PIC16(L)F1934/1936/1937 Family Silicon Errata and Data Sheet Clarification

The PIC16(L)F1934/1936/1937 family devices that you have received conform functionally to the current Device Data Sheet (DS41364E), except for the anomalies described in this document.

FIGURE 1: INSTRUCTION CYCLE DELAY CALCULATION EXAMPLE

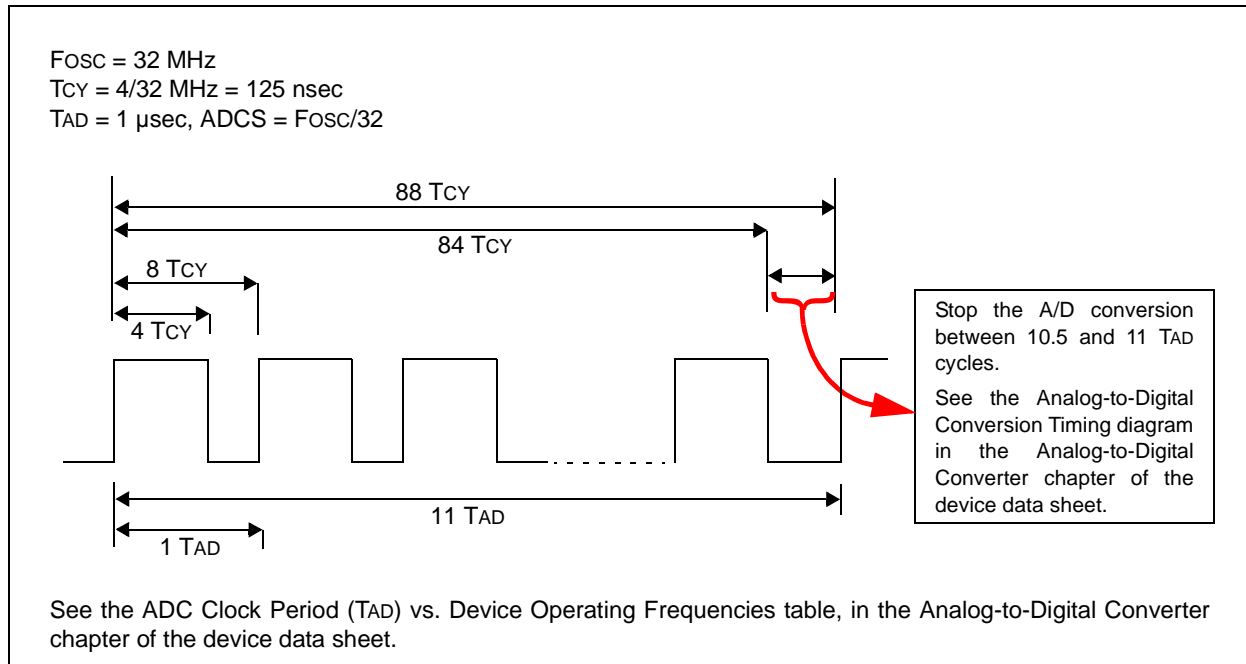
An ADC conversion may not complete under these conditions:

1. When FOSC is greater than 8 MHz and it is the clock source used for the ADC converter.
2. The ADC is operating from its dedicated internal FRC oscillator and the device is not in Sleep mode (any FOSC frequency).

When this occurs, the ADC Interrupt Flag (ADIF) does not get set, the GO/DONE bit does not get cleared, and the conversion result does not get loaded into the ADRESH and ADRESL result registers.

Method 3: This method is provided if the application cannot use Sleep mode and requires continuous operation at frequencies above 8 MHz. This method requires early termination of an ADC conversion. Provide a fixed time delay in software to stop the A-to-D conversion manually, after all 10 bits are converted, but before the conversion would complete automatically. The conversion is stopped by clearing the GO/DONE bit in software. The GO/DONE bit must be cleared during the last 1/2 TAD cycle, before the conversion would have completed automatically. Refer to [Figure 1](#) for details.

In [Figure 1](#), 88 instruction cycles (TCY) will be required to complete the full conversion. Each TAD cycle consists of 8 TCY periods. A fixed delay is

provided to stop the A/D conversion after 86 instruction cycles and terminate the conversion at the correct time as shown in the figure above.
